ADMINISTRATIVE AMENDMENT (PD) ADD2020-00129(A)

ADMINISTRATIVE AMENDMENT
LEE COUNTY, FLORIDA

NOTE: This resolution has been amended to revise the dwelling unit type maximums established by Resolution Z-06-039 to reflect the conversion of townhome units to single-family dwelling units as outlined in the Trip Generation Comparison Memorandum attached hereto as Exhibit "G." Revisions are noted in underlined text.

**AERIAL WITH PROPOSED SITE PLAN,
BALD EAGLE NEST TREE LOCATION, AND SURROUNDING AREAS**

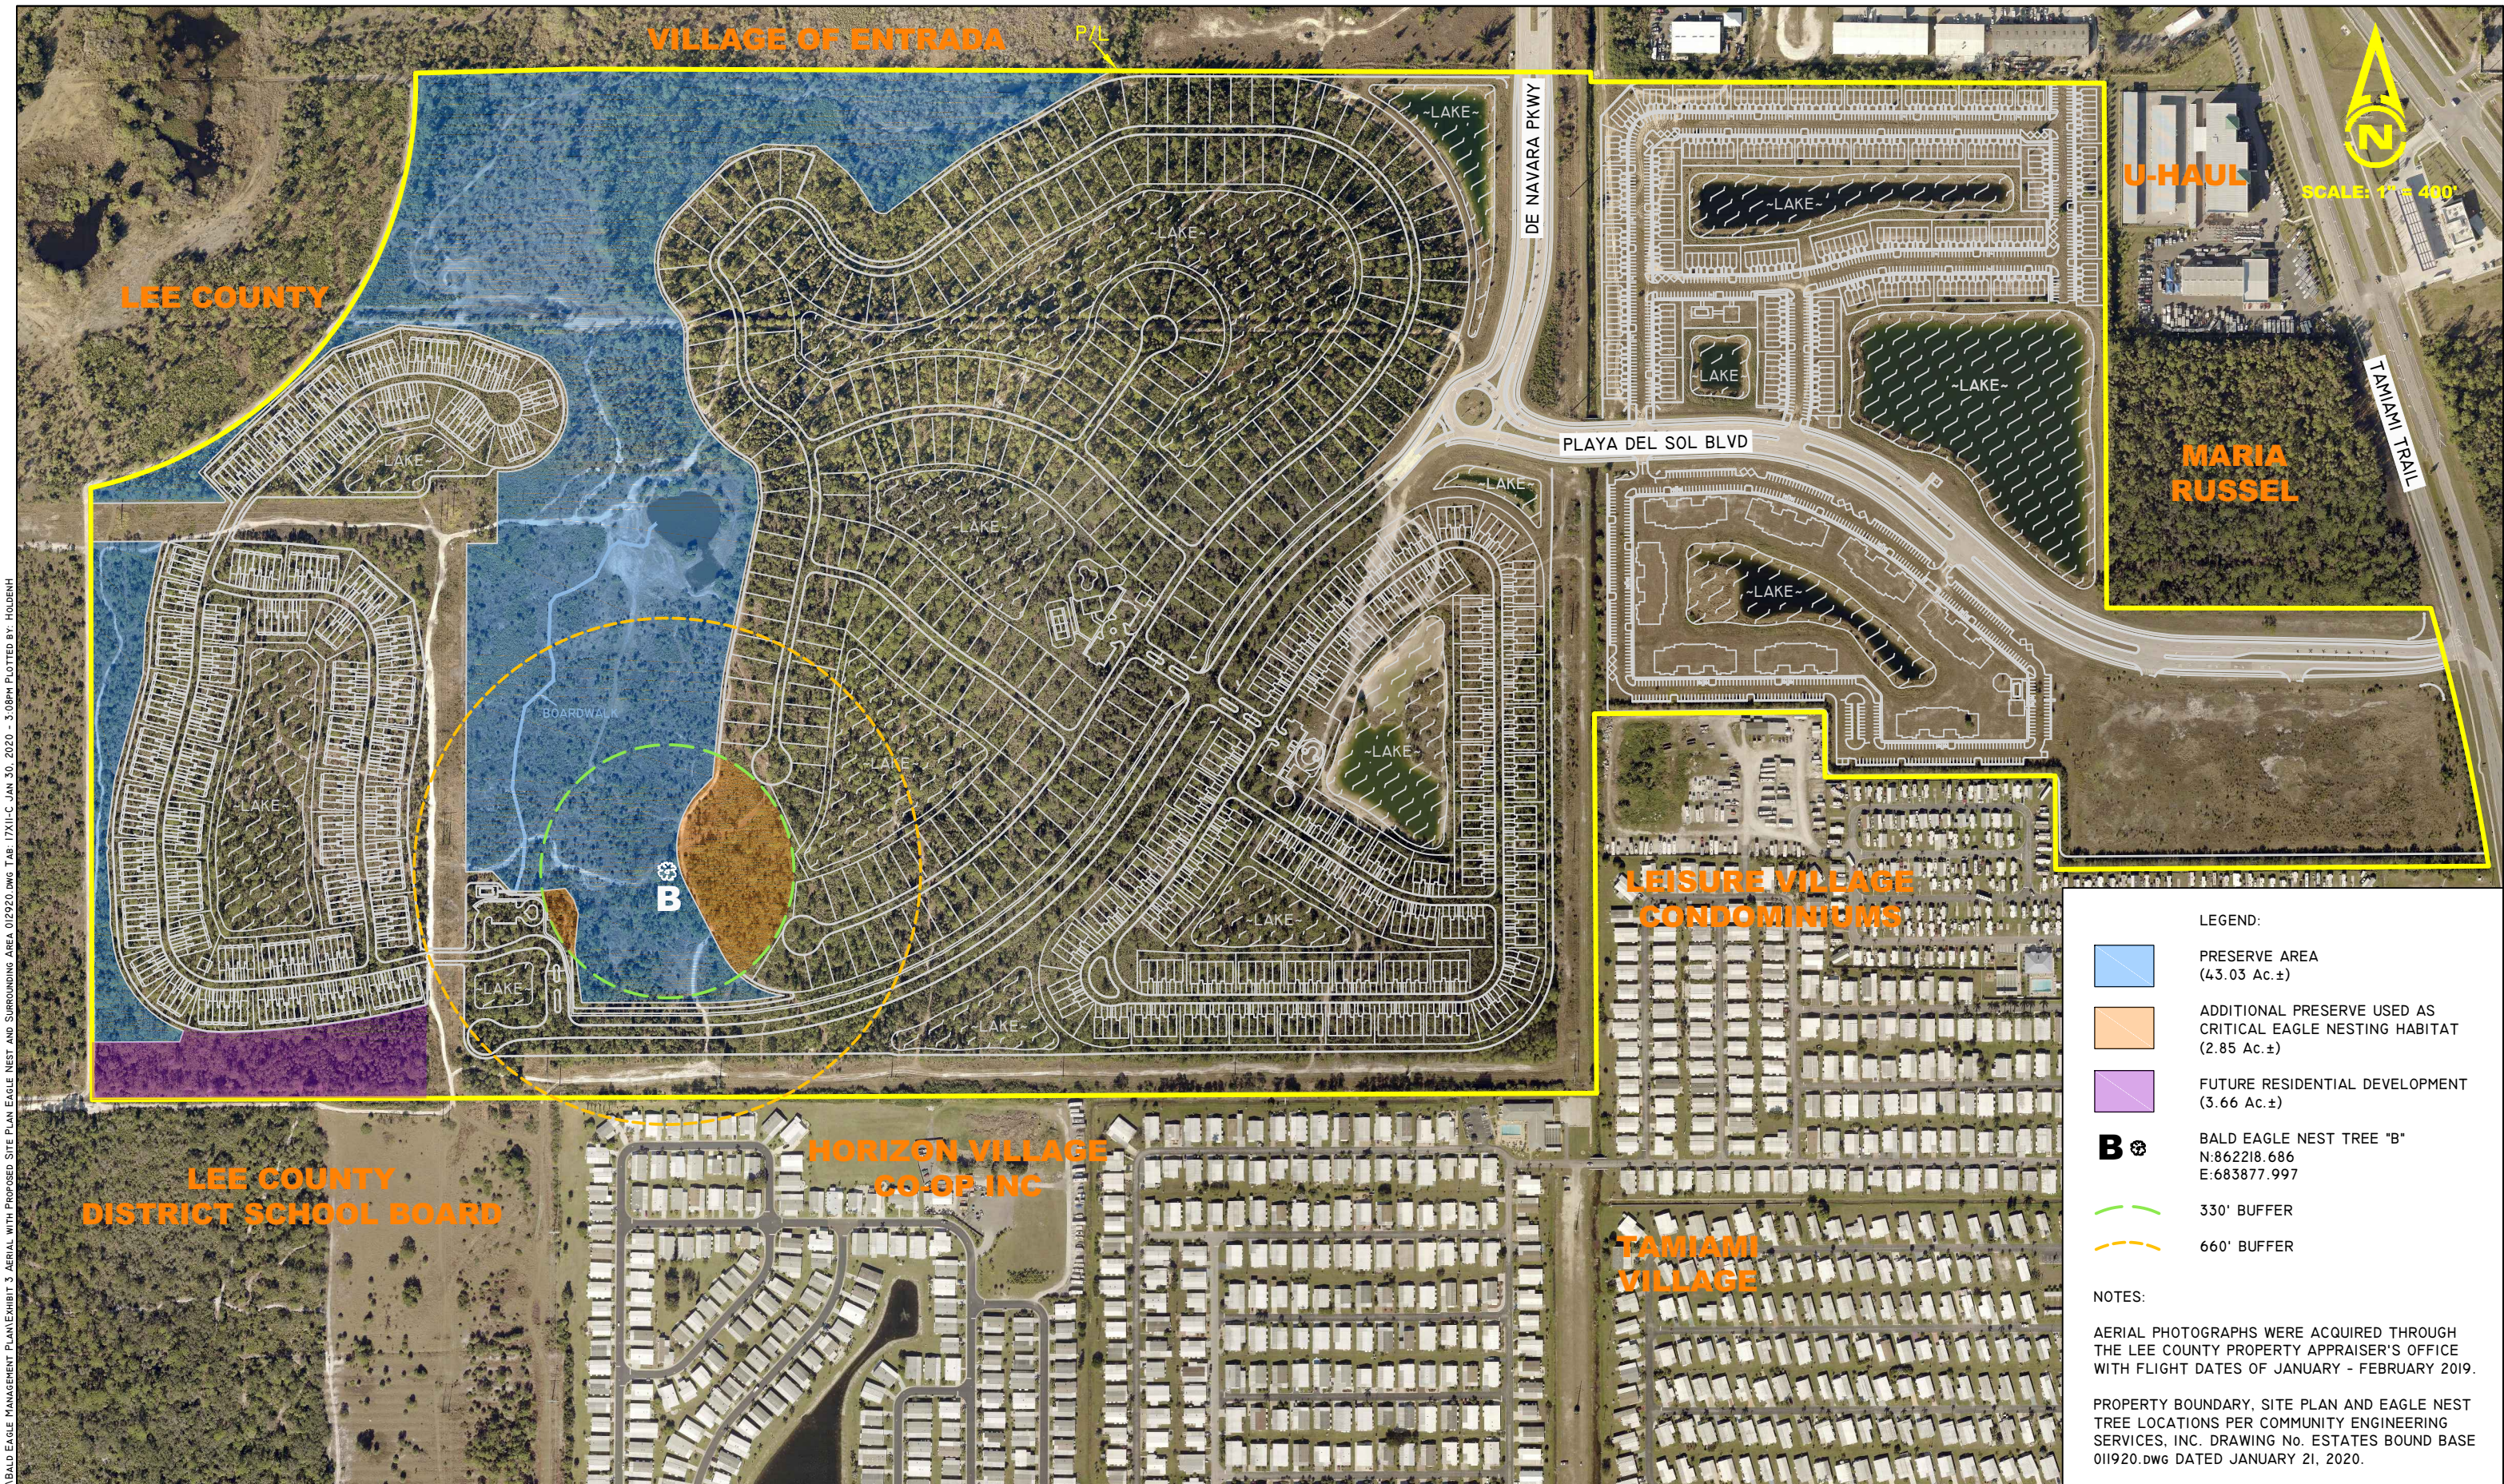
The applicant proposes to modify the site plan as depicted on Exhibit 3. The site plan modifications include the removal of several single-family lots and a section of road within the 330-foot buffer zone. Also, a small portion of the amenity area located southwest of the nest has been removed. Therefore, no development will occur closer than 330 feet from the nest tree. In addition, the applicant proposes to preserve 2.85± acres within the 330-foot buffer zone as a critical eagle nesting habitat. The 2.85± acres will be placed under conservation easement to Lee County and will be maintained free of exotic vegetation by the Project’s long-term management entity (e.g., homeowner’s association). Exotic vegetation to be eradicated includes, but is not limited to, the 21 species of prohibited invasive exotic species listed in Section 10-420(h) of the LDC.

RE: Administrative Zoning Amendment
 The Estates at Entrada
 Project No. 20DRH3329

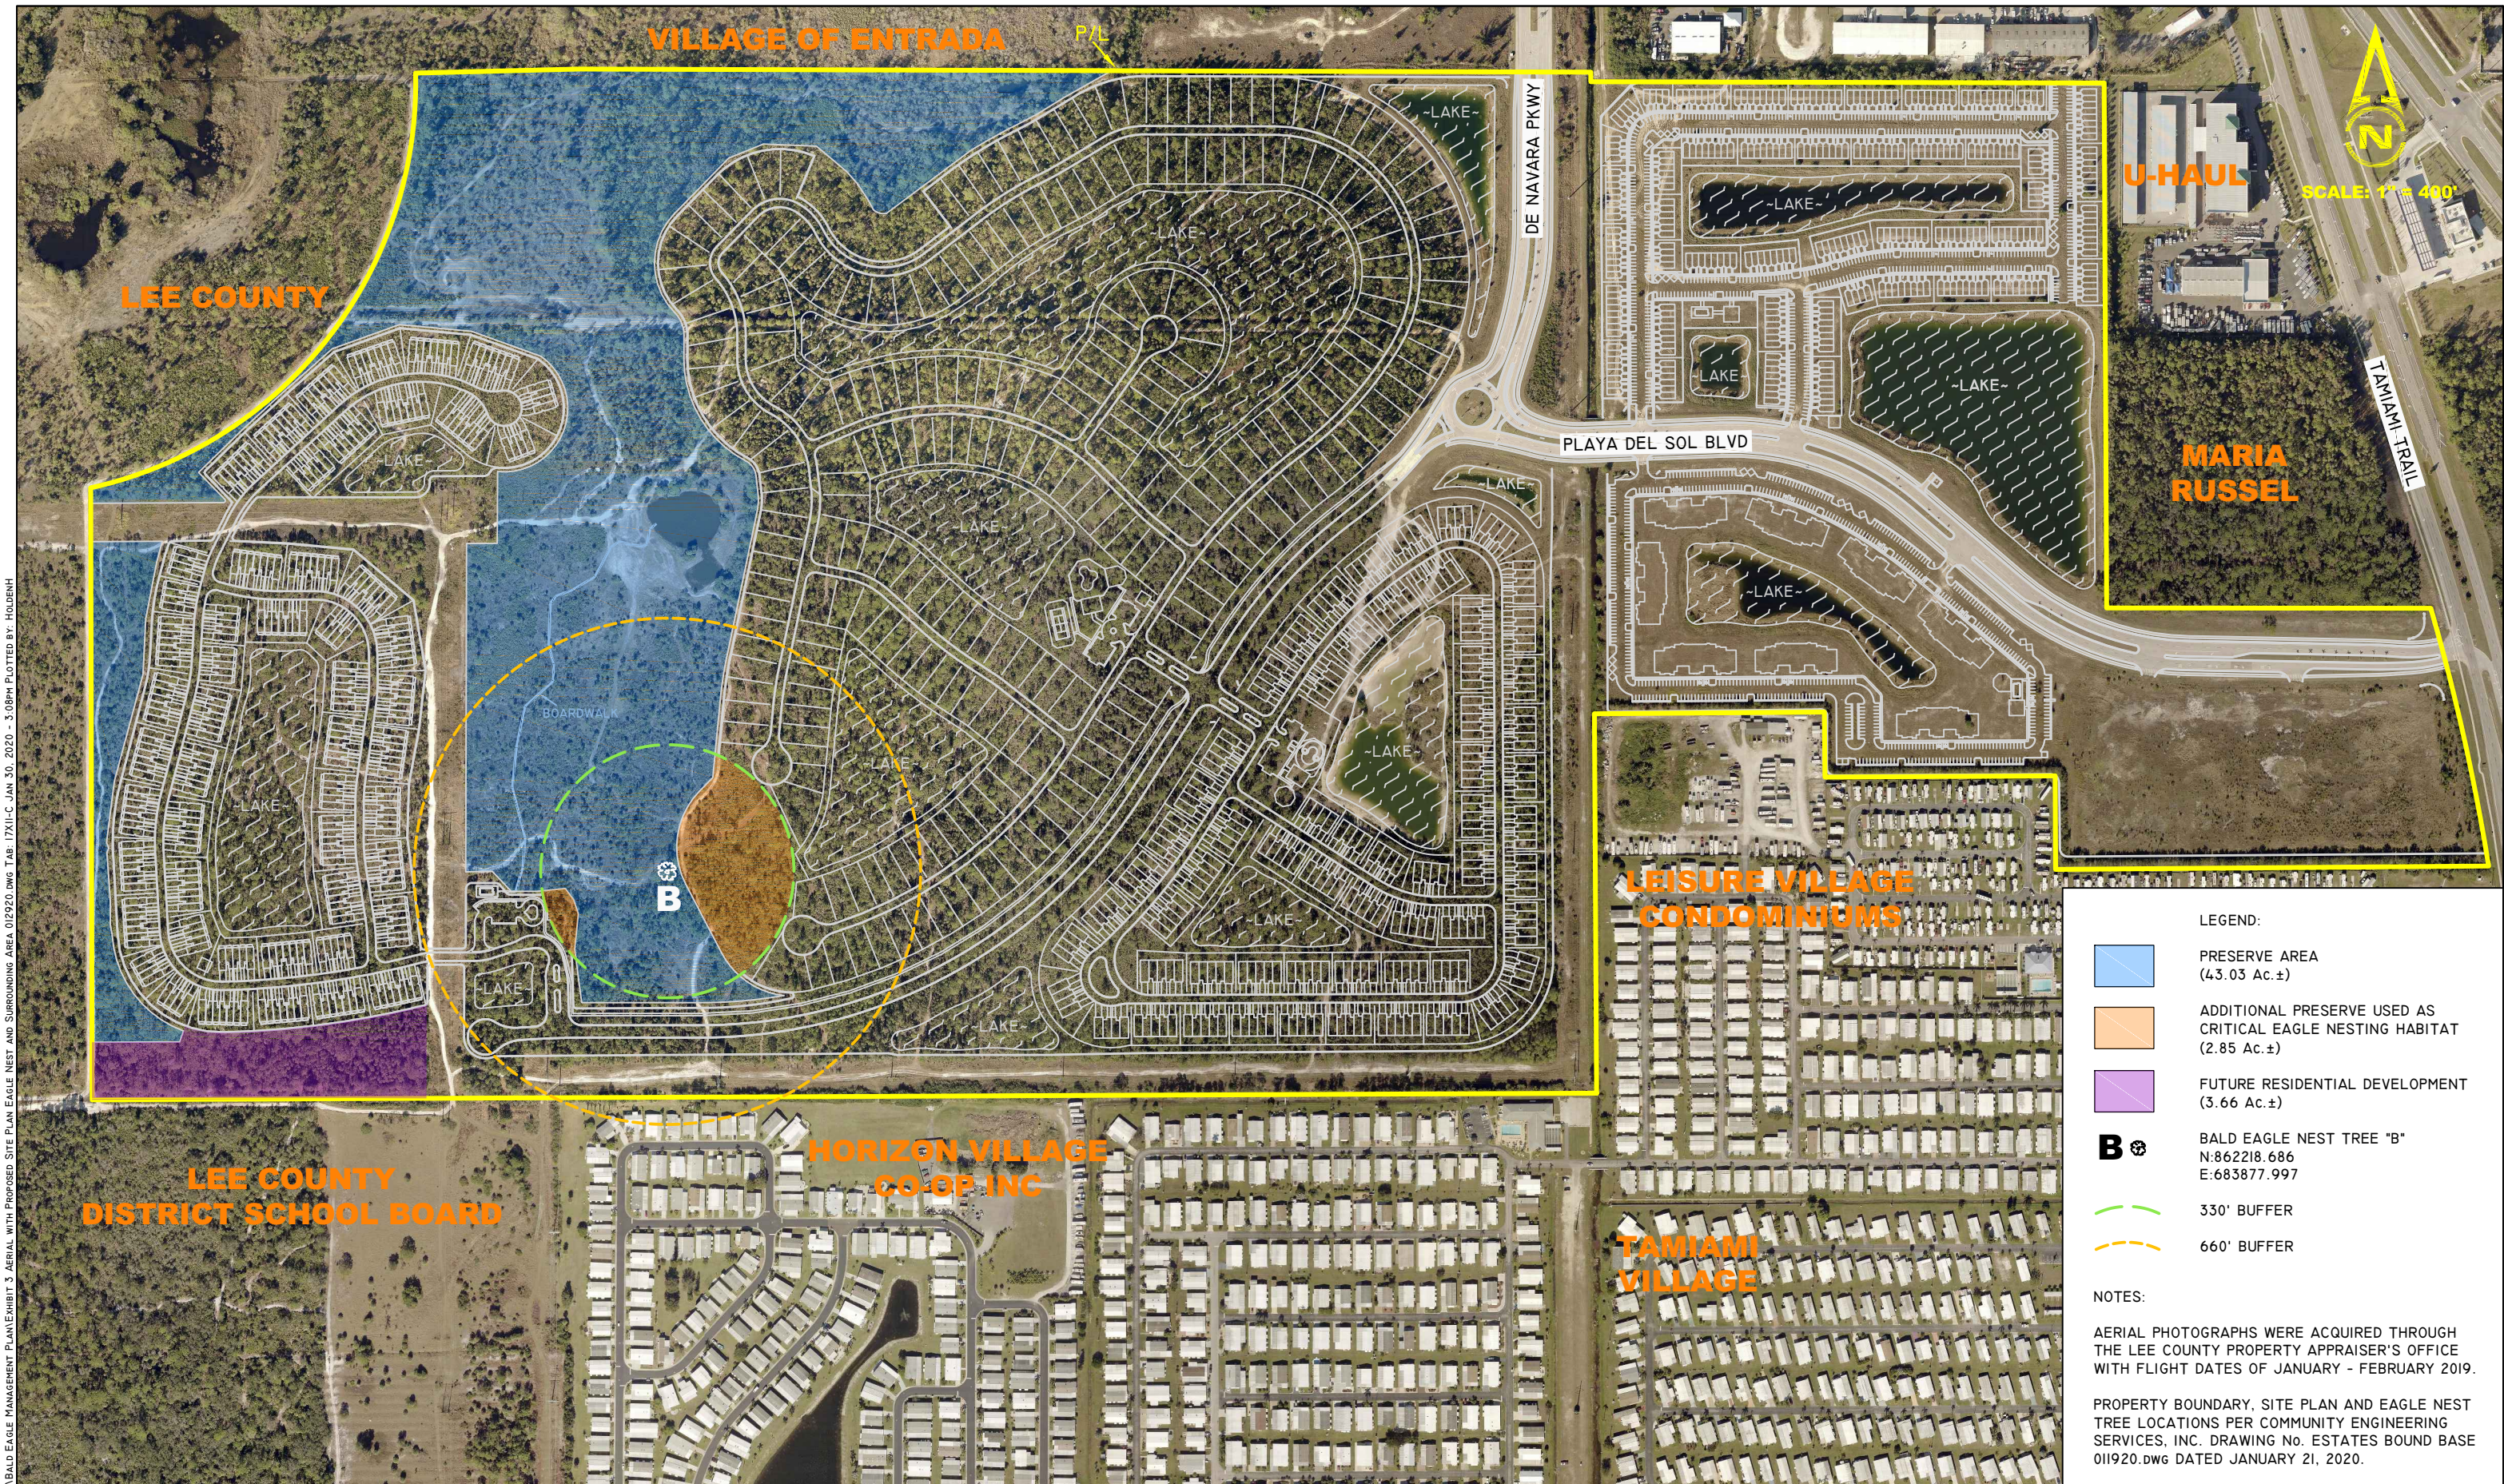
This memo and attached information are provided in support of the Administrative Zoning Amendment proposed for Estates at Entrada (Project) located in Section 27 and 28, Township 43 South, Range 24 East, Lee County. The attached aerial is Exhibit 3 of the Project's Bald Eagle Management Plan (BEMP), previously-approved in March 2020. Exhibit 3 depicts an amenity site and 27 single-family homes within the 330-foot and 660-foot buffer zones of Nest Tree B. The attached Master Site Plan, which is proposed as part of the administrative zoning amendment, removes the amenity site and includes 30 single-family homes within the 330-foot and 660-foot buffer zones of Nest Tree B.

Removing the amenity site and adding single-family homes in its place will provide a benefit to bald eagles (*Haliaeetus leucocephalus*) that may utilize Nest Tree B. Amenity centers tend to promote congregations of people which can generate noise and potentially disturb nesting bald eagles. Noise abatement is often a component of U.S. Fish and Wildlife Service permits or other disturbance reduction measures for bald eagles; thus, having single-family homes in place of an amenity center is likely to promote noise reduction. Additionally, the proposed change to the Master Site Plan to remove the amenity center and add single-family homes is consistent with the protection measures currently provided for Nest Tree B in the March 2020 BEMP.
